1. COMMENTS & IDEAS

North & West

Title	HEATHROW PREFERRED COMPONENTS NOV 2018: (1) COMMENTS & IDEAS: NORTH & WEST	
Prepared for	Heathrow Strategic Planning Group	
Plan ref.	HPC-nov18-C&I-NW	
Version	V01	Version history
Issue date	14.12.18	V01 - 14.12.18 - KU
Drawn by	KU

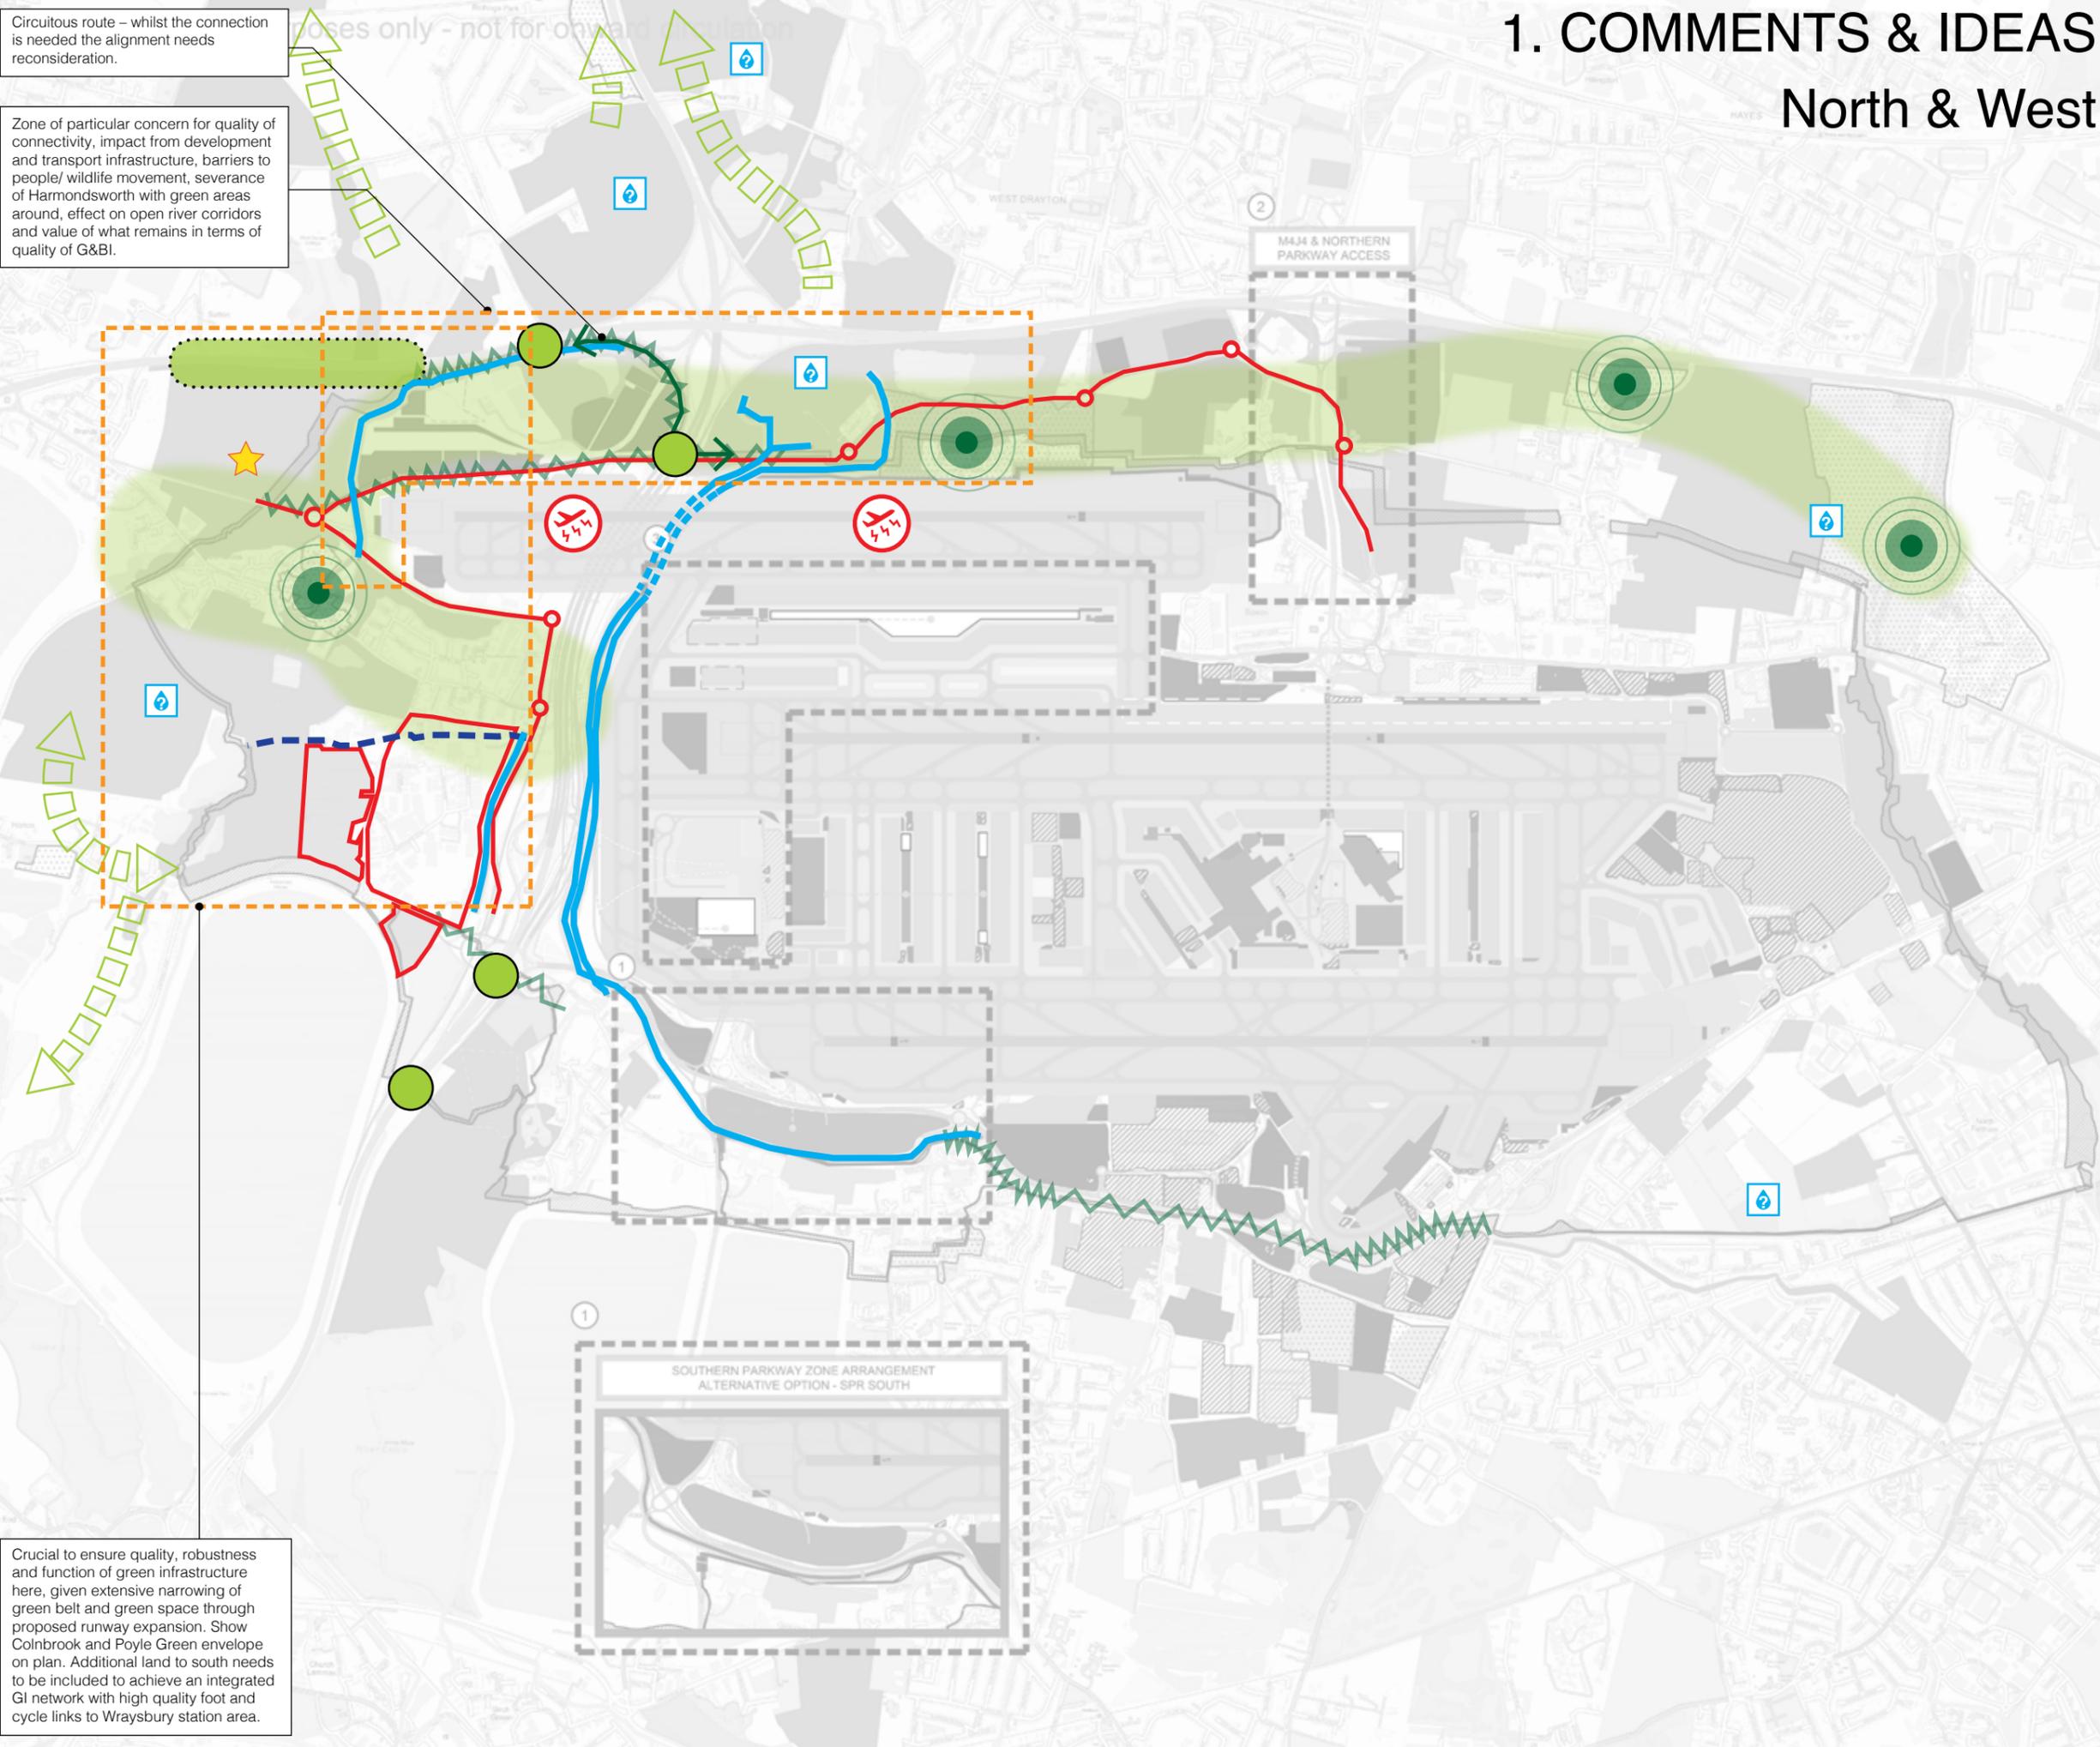
Circuitous route – whilst the connection is needed the alignment needs reconsideration.

Zone of particular concern for quality of connectivity, impact from development and transport infrastructure, barriers to people/ wildlife movement, severance of Harmondsworth with green areas around, effect on open river corridors and value of what remains in terms of quality of G&BI.

Crucial to ensure quality, robustness and function of green infrastructure here, given extensive narrowing of green belt and green space through proposed runway expansion. Show Colnbrook and Poyle Green envelope on plan. Additional land to south needs to be included to achieve an integrated GI network with high quality foot and cycle links to Wraybury station area.

-  Adopt a unified, strategic approach to GI in the northern area to improve the setting of heritage assets, create a green ring around Colnbrook and Poyle and generally achieve high quality connectivity for people and wildlife (area coloured is symbolic rather than inferring a detailed zone).

-  Greater connectivity with & improvement of green infrastructure beyond identified areas is required to secure comprehensive mitigation and integration (locations indicated are examples only).

-  *Context of development, transport infrastructure very concerning for quality of green corridors/ routes for walking and cycling – rethink required.

-  Green Bridges rather than underpasses (or standard bridge) over the M25 and M4.
-  Zone for additional bridging opportunities (including a green bridge) over M4 to improve quality of green integration/ connection north-south, and with residential areas and Slough.

-  *What will be the quality of the new open river corridors? Need to show what is netted/ not and provision for green corridors (for people and wildlife) to understand value/ function across the plan. New channels and surrounding habitat must achieve WFD 'Good Ecological Potential' standard with a minimum 20m buffer, naturalised channels and complex riparian habitats. Factor in extra resilience.

-  Covered river corridors - unproven method of mitigation, no evidence of how this would be maintained. Addition of physical barriers to detriment of migratory species.

-  Poyle Channel corridor improvements (design quality, access, river environment, building setting).
-  *Flood storage areas (FSA) not shown on plan. Concern over storage on former landfill (contamination). Where will excavated soil go? Flooding capacity appears to assess only 1 of 3 sources (river flooding, but not groundwater or surface water), meaning storage volume insufficient. Incorporate natural flood management in to green space development and management (areas with symbols are examples).

-  Opportunities for multifunctional use and good design in (existing and any new) industrial estates and re-routed roads.
-  What is the noise and visual impact of (elevated) runway on area around (also newly overflow areas beyond masterplan; 3D images required), and what is the mitigation proposed? (also applicable to road noise where roads or PROW are realigned).

-  Opportunity for 'beacon' visitor attraction (plane spotters) to encourage use of area (e.g. Northolt Northala Fields). Location is purely illustrative.
